PRODUCT CHANGE | Medium Link Skyline Bracket | Narrow | 38mm V2

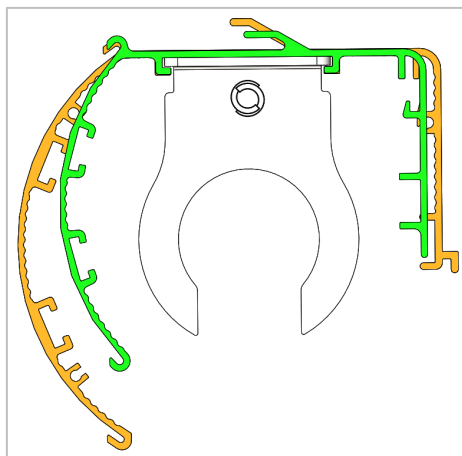
- Cut-out allows for installation into a Cassette 100/120 extrusion.
- Tapped M4 hole allows for secure installation to prevent bracket rattling (no screw included).

- The new bracket enables to use link systems in cassettes.

- The bracket has small cut-outs on both sides.
